RE: **34-DR-2021**
4141 Scottsdale
2164B (Key Code)

The Planning & Development Services Division has completed the review of the above referenced development application submitted on 9/13/21. The following **1st Review Comments** represent the review performed by our team and is intended to provide you with guidance for compliance with city codes, policies, and guidelines related to this application.

Segment 2 – Downtown

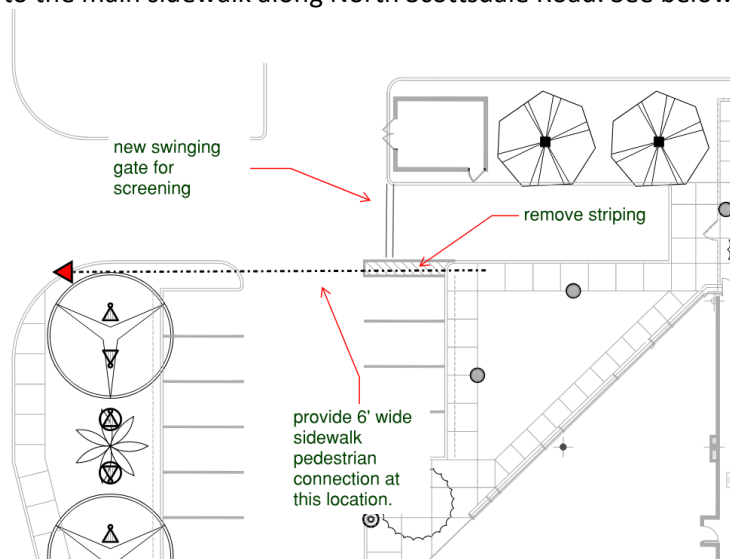
17. Please revise the hardscape, concrete, and pedestrian elements to have to have Earthtone red hues and smooth stucco finishes per the identified by the Scottsdale Road Streetscape Design Guidelines Segment 2:

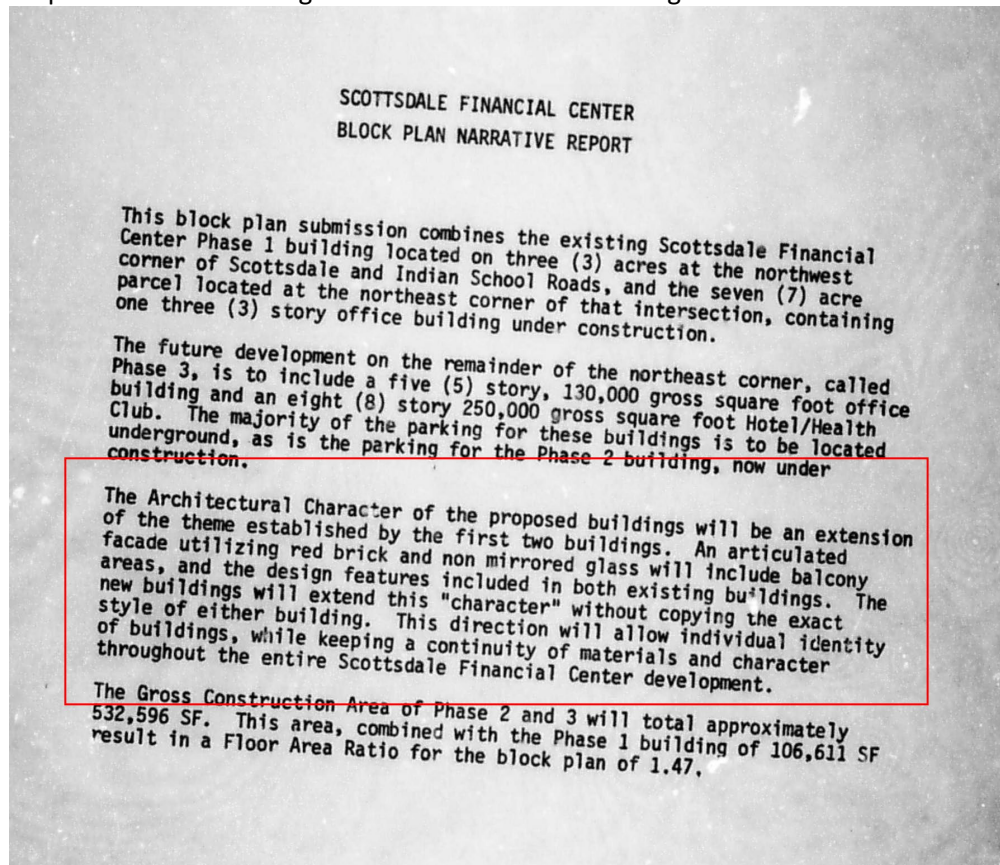
28. Please update the architectural setting to incorporate red brick as found throughout the three other buildings at the intersection of North Scottsdale Road and East Indian School Road and

emphasized in the zoning case. See below for the zoning narrative:
